System	Date of Issue	Bulletin Number	Bulletin Type
Odyne System G2V2 Freightliners	9/18/14	00017	<input type="checkbox"/> Field Service Action <input type="checkbox"/> Technical Service Bulletin <input checked="" type="checkbox"/> Technical Service Advisory

Title: Change CAN Data Link Connection Point (CANJ1939)

Issue: Smartplex CAN switch module intolerant of 40 ohm bus impedance; must be 60 ohm standard. Potentially causes CAN bus corruption and non-functional switch interface.

*Cable / zip ties behind
instrument cluster panel*

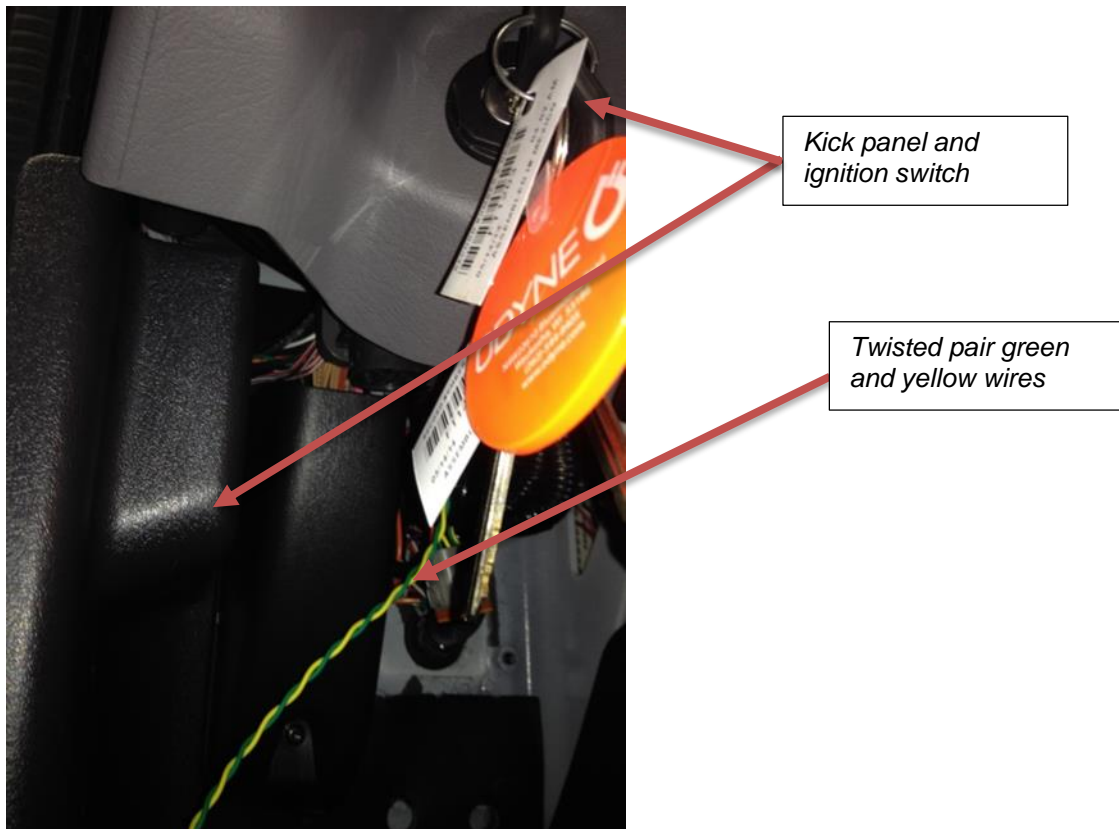
6. Route the CAN harness twisted pair wire assembly through and behind the instrument cluster panel and down to the OEM diagnostic port and secure with cable / zip ties.

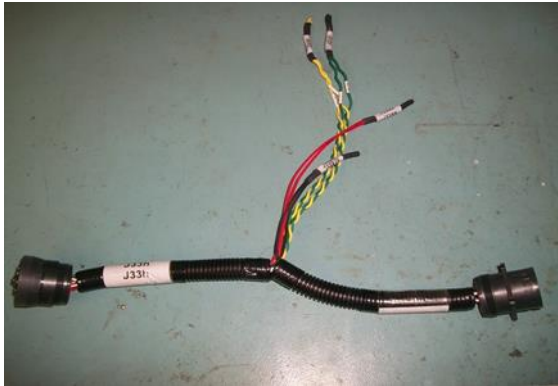
7. Remove zip / cable ties holding the harness to the OBD (On Board Diagnostic) port to access wire harness.
8. Remove the LH Air vent, LH lower kick panel and the ignition switch assembly in order to access the cab harness and the original OBD connector that is connected to the J33h.

9. Locate and remove the Odyne TEE harness J33g and J33h which is no longer utilized.
 - a. On the harness side, cut the Red 12v DC wire at the J33S9 splice. Apply heat shrink to seal open wire. Stuff back into wire loom.
 - b. On the harness side, cut the Black ground wire at the J33S10 splice. Apply heat shrink to seal open wire. Stuff back into wire loom.
 - c. Cut the twisted pair wires Green J33S7 and Yellow J33S8 at splices.
